Historic Preservation Design Review

HP-13-15, 5 S. Main St. – J. O’Grady’s Restaurant (City)

Request: Historic Preservation Design Review approval to alter the front and side façade of the building at the corner of Main St. and Liberty St. in order to open a restaurant.

Side of Pierson Building Showing Proposed New Facade Additions
 Sumter, South Carolina

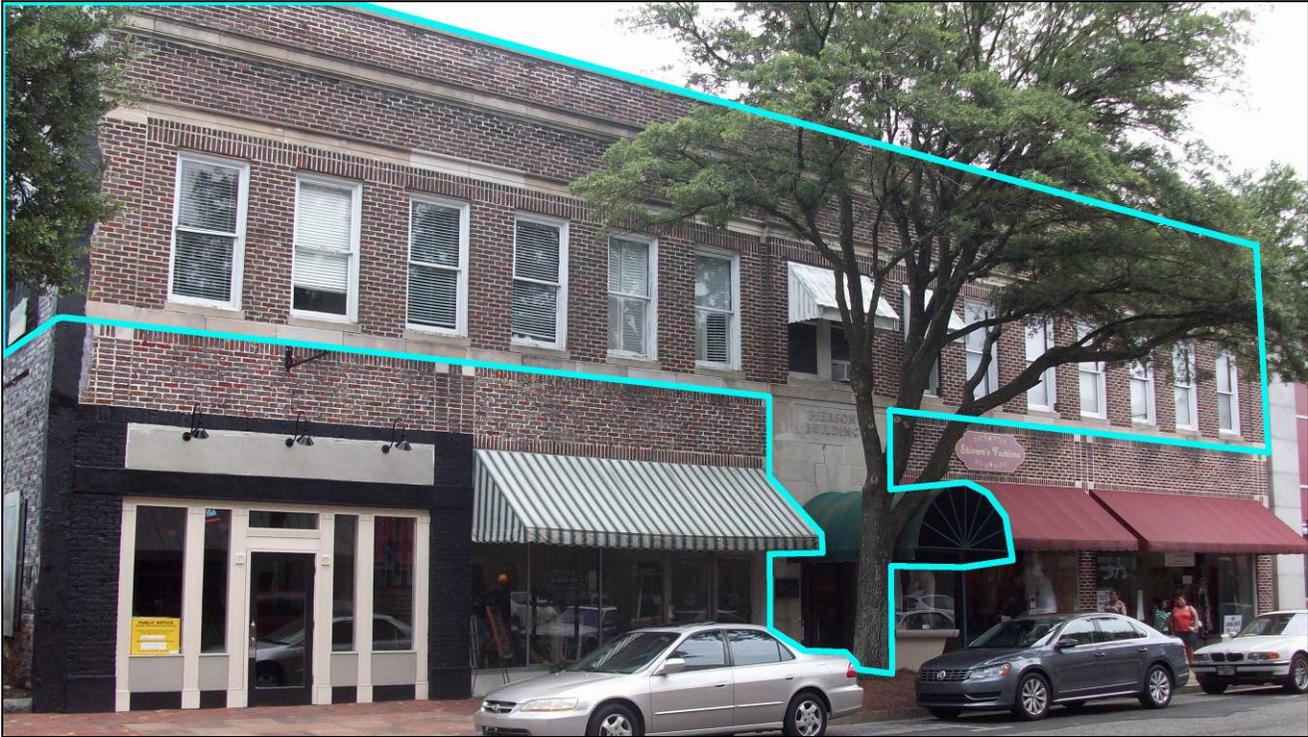
- Several of the storefronts on this building have been altered in configuration so that they are individual in appearance.
- This request is to alter the lower story of the front and side façades of the corner of the building. This architecture can be viewed as separate from the upper story and the adjacent storefronts.

Above: The area of the building designated as part of the J. O'Grady's Restaurant for the purposes of exterior changes. Likewise, the adjacent storefronts would be given the same area to treat as part of their exterior for the sake of future façade changes.

Below: Staff recommends that the upper story and front entrance of the building should be treated as a separate space for the sake of future exterior façade changes.

- That the upper story of the Pierson building should be treated as a separate space for the sake of any future exterior façade changes.
- That either a ledge and plantings (similar to the images provided) or a new awning is placed above this storefront.
- That the edge of the upper story on the front façade should be painted to match the existing concrete.

The photos are shown below:

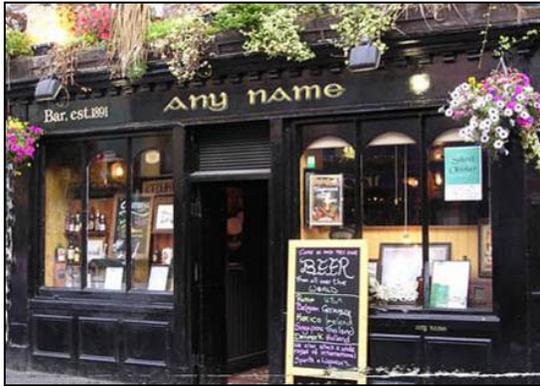
The applicant also submitted several photos of similar European-style pub and restaurant façades so that his vision for the project would be clear. Note that many of these façades have ledges and plantings at the top. The applicant intends to recreate this look on the front and side of the façade at 5 S. Main St.

- The awning has been removed from the façade of 5 S. Main St. However, the applicant proposes to construct a ledge along the top of the lower façade and use plantings as shown in some of the pictures of European style restaurants. This will provide visual interest and consistency with the pattern of awnings on the rest of the façade.
- Staff recommends that either ledges with plantings (similar to the images provided) or a new awning is placed above this storefront.

J. O'GRADY'S

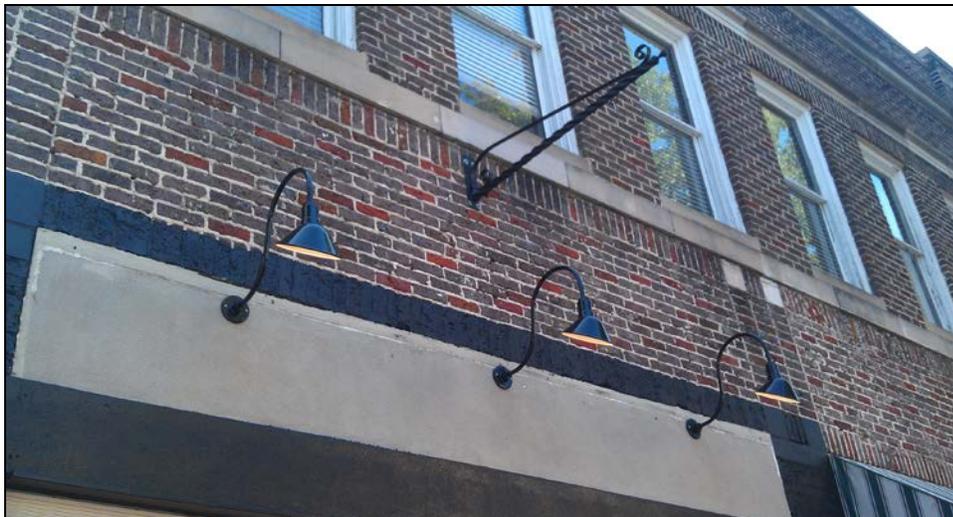
- The font submitted by the applicant is Roman Classic Lettering, in Gold. Below is a closer view of the proposed font and color of the sign lettering:
